CLIENT: WT Leung Architects, Inc

PROJECT NO.: VAN-00217815

SERVICE PROVIDED: Review of Shoring construction and Anchor Testing

LOCATION: 4083 Cambie St, Vancouver, BC

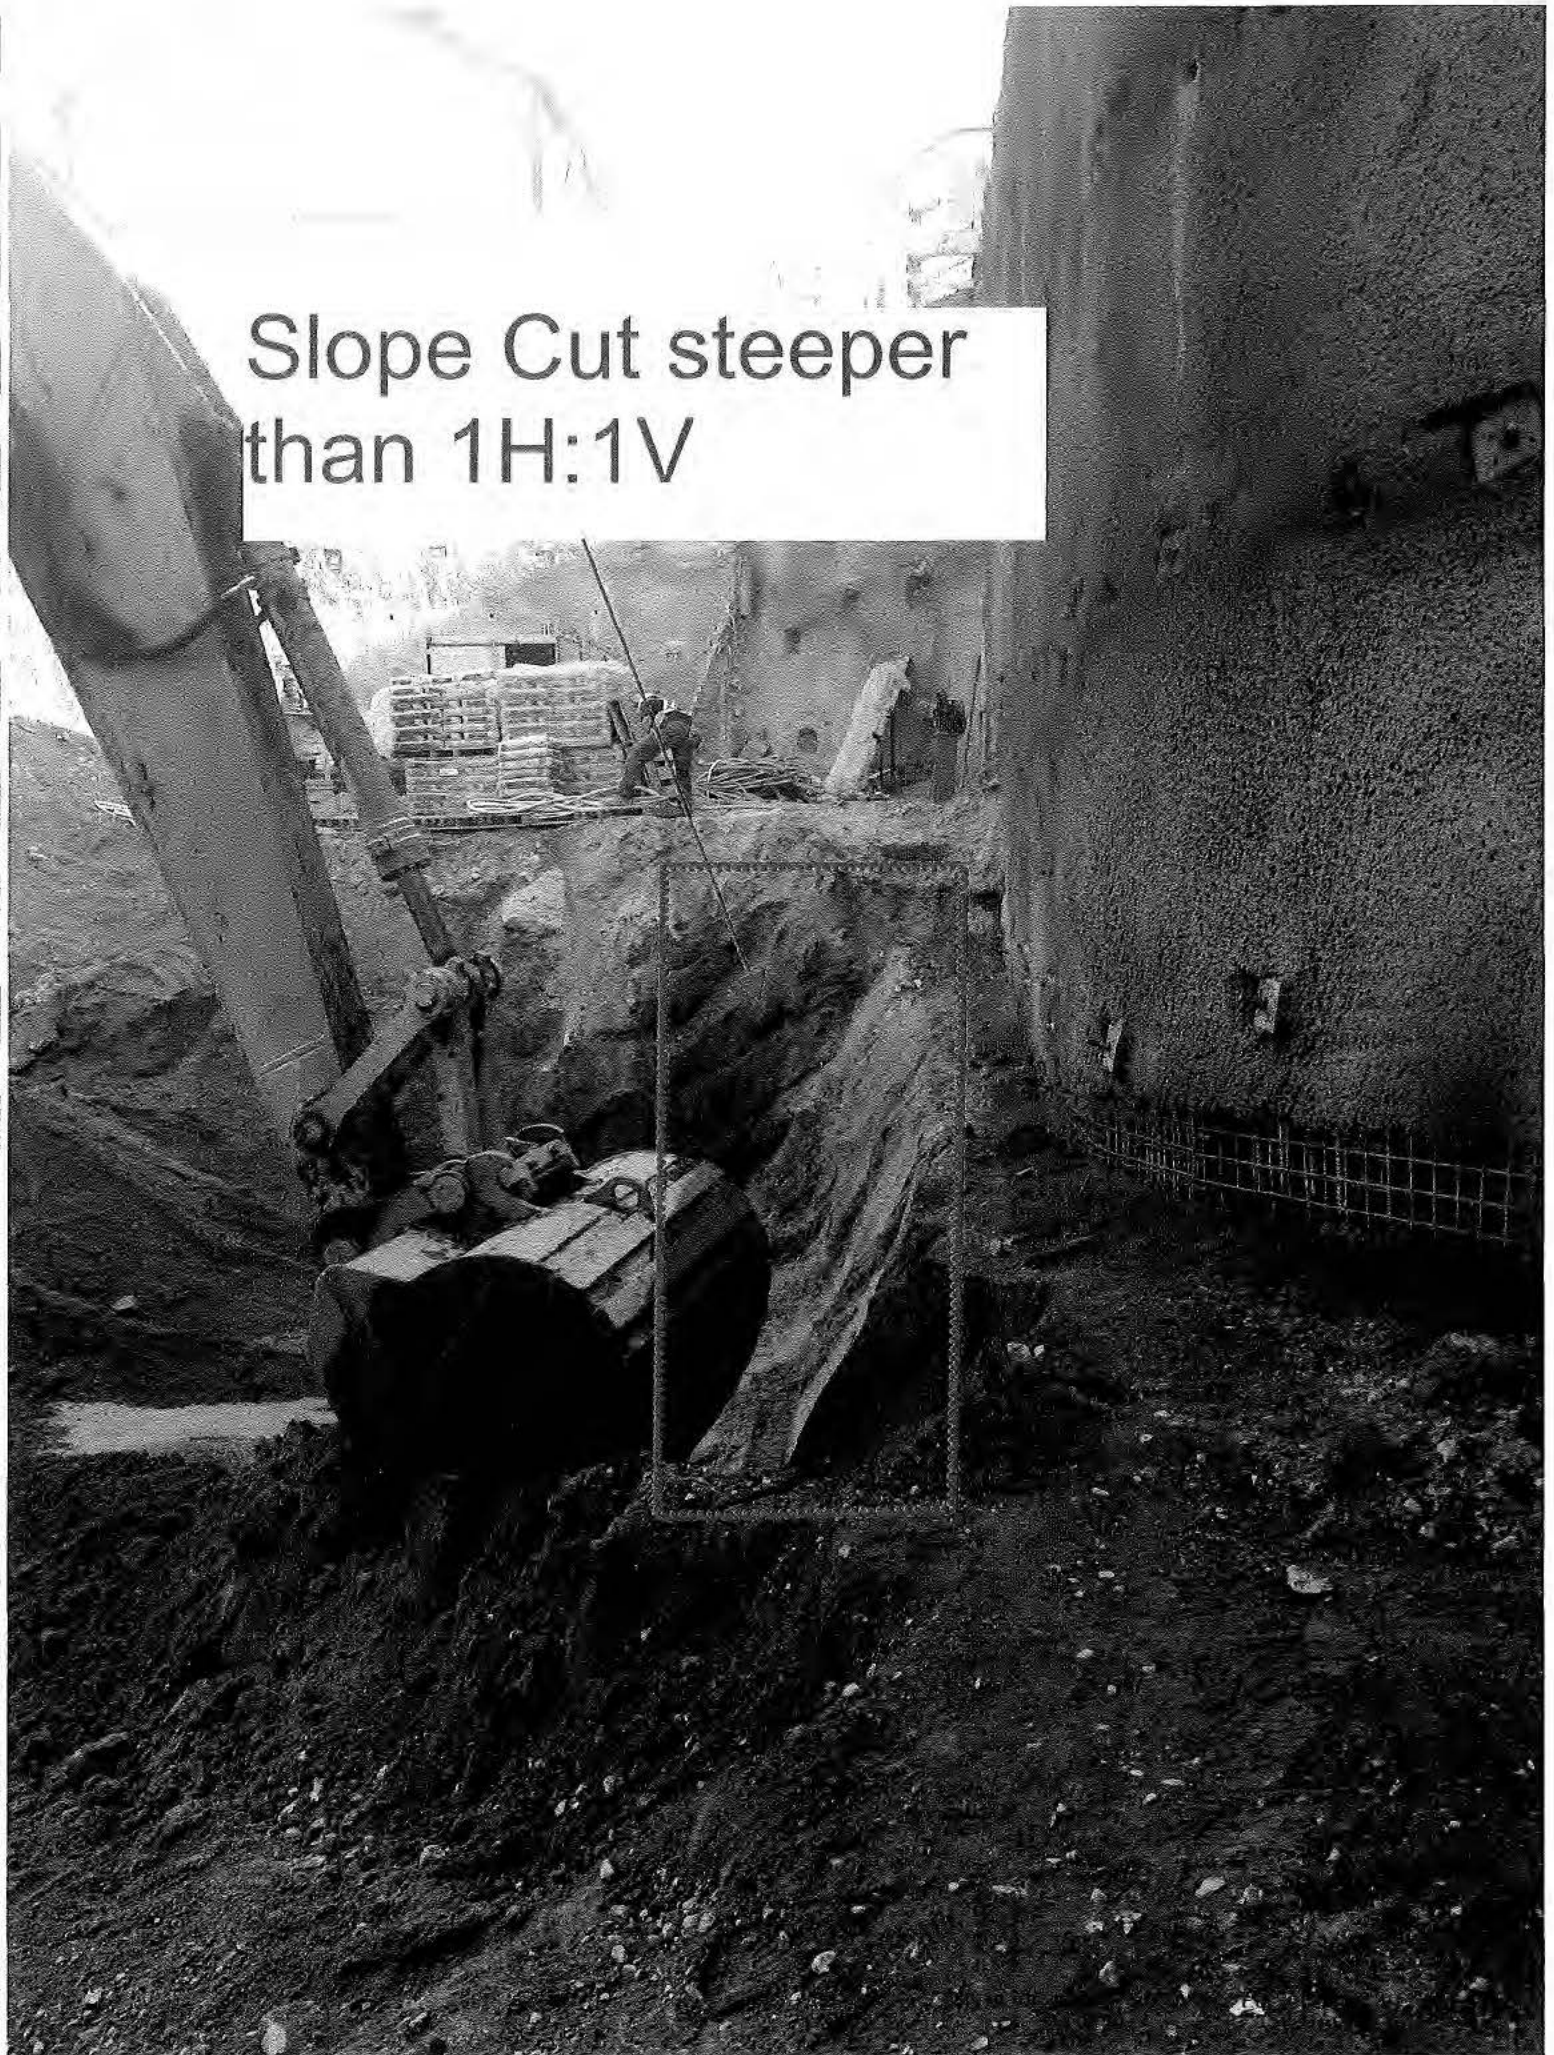
NOTE: slope cuts were observed to be steeper than 1H:1V and spacing from Shotcrete Face and next stage of Excavation are shown on Design Drawings to be 3ft which was observed 2ft. The subcontractor Supervisor was informed the issue. Two photo attached for more information.

SECTION "1"

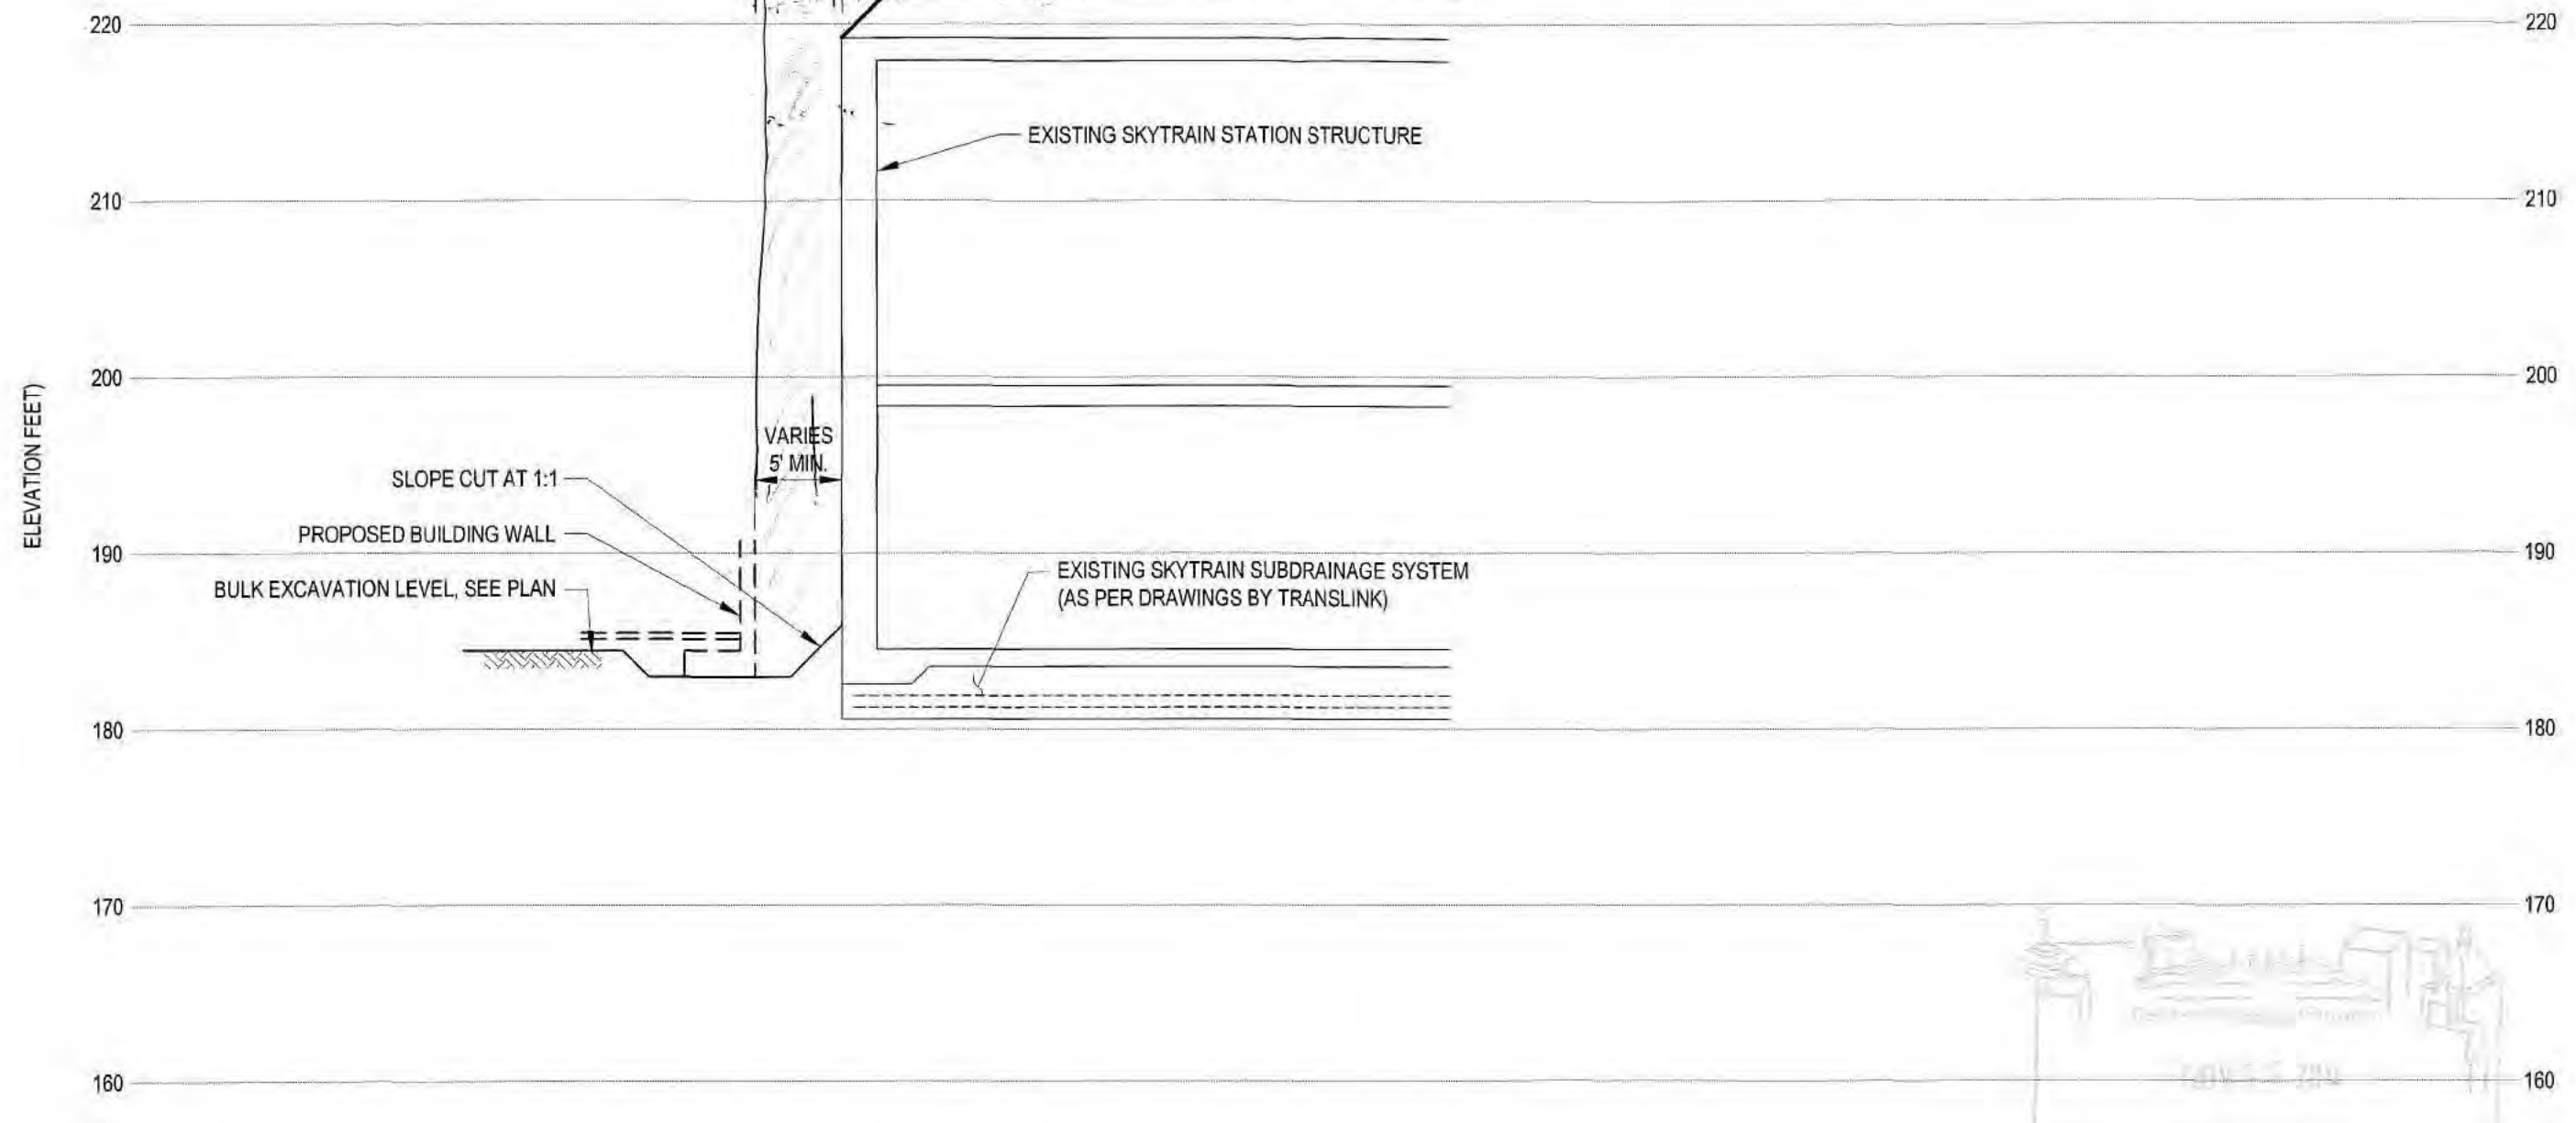
We are unable to Approve the over Excavation of Cambie st as per section 1/ G2 as this will totally close sidewalk to all pedestrians. Excavation needs to be done in a way in which the sidewalk along Cambie st is maintained at all times for pedestrians in this extremely busy Transit location. Please revise and re-submit. *Baran*
